SB-GA8-2011-82

Issue 2

Service Bulletin

Alcor CHT Probe and Extension Cable

Figure 1 – Approximate Location for CHT Probe Installation. Viewed from RHS of aircraft.

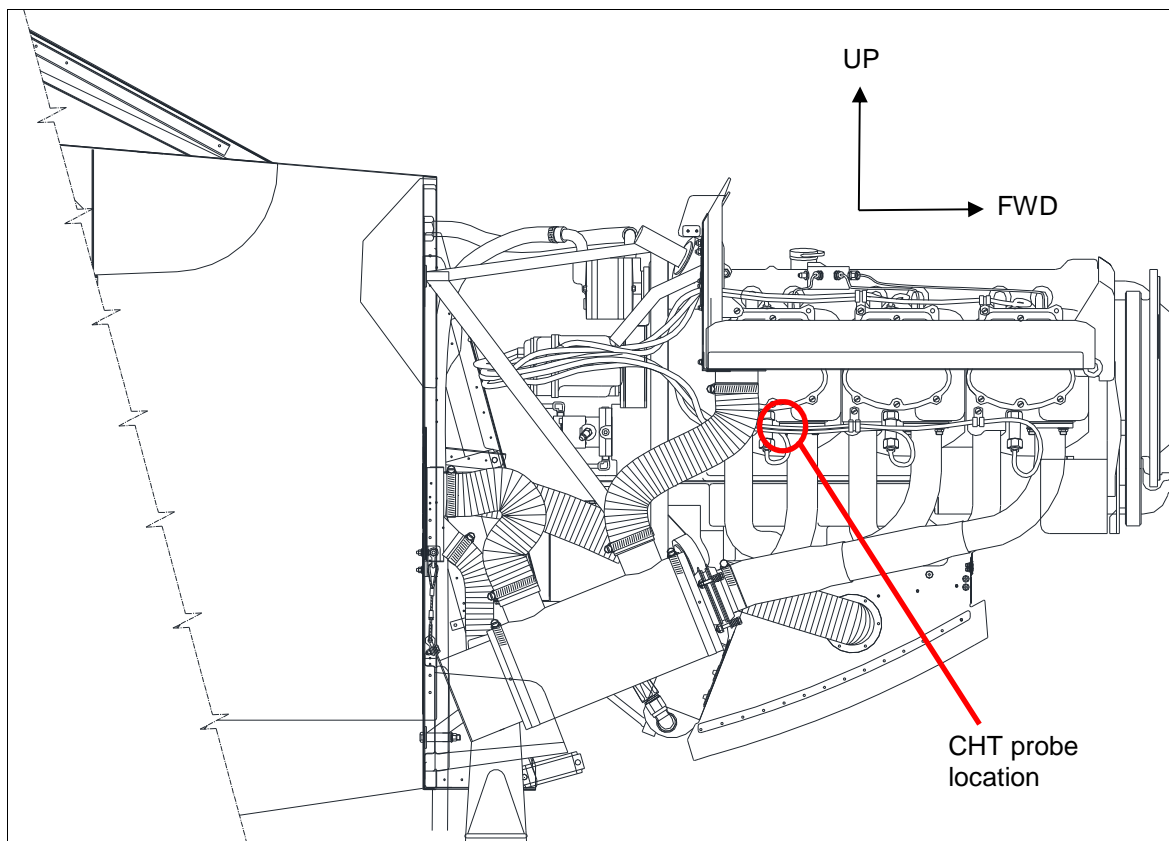
3. Remove the existing GA200-772011-013 CHT Probe Assembly and the loom that connects to the CHT Indicator. See Figure 1 for CHT Probe location. Carefully remove sealant, as required, from the firewall to allow loom removal.

4. In the same location where the CHT probe was removed, fully insert replacement Bayonet Probe (Item 1) with the Alcor adaptor into thermowell, aligning locking pin with cap slot. Push and turn cap clockwise to lock.

Figure 2 – Schematic diagram of CHT wiring.

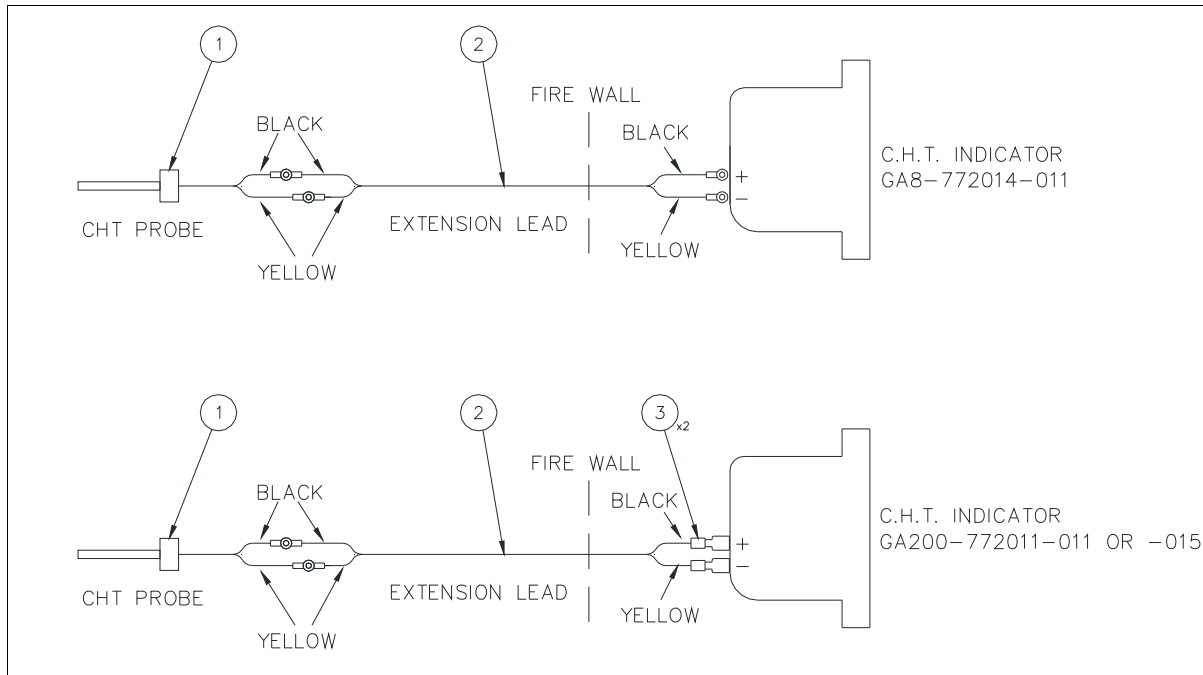
5. Route the Extension Lead (Item 2) via the same path as the previously removed lead. The end of the Extension Lead which has a screw fitted, shall be located forward of the firewall. See Figures 2 and 3.
6. If the part number of the CHT Indicator is either GA200-772011-011 or GA200-772011-015, attach FIQC 1.25-6.4 DG terminal lugs (Item 3) to the ends of the Extension Lead which are aft of the firewall. This is not required if an Alcor Inc based CHT Indicator (GippsAero part number GA8-772014-011) is installed.
7. Attach to the extension lead to the CHT Indicator in accordance with Figure 2.

15. Attach the Extension Lead (Item 2) to the CHT Probe using screws already attached to the wires (see Figures 3 and 4) to fasten together the ring terminals. Refer to Figure 2 for wiring schematic.
16. Slide the supplied fiberglass insulation sleeve so that the connections between the Extension Lead and the CHT Probe lead are both covered.
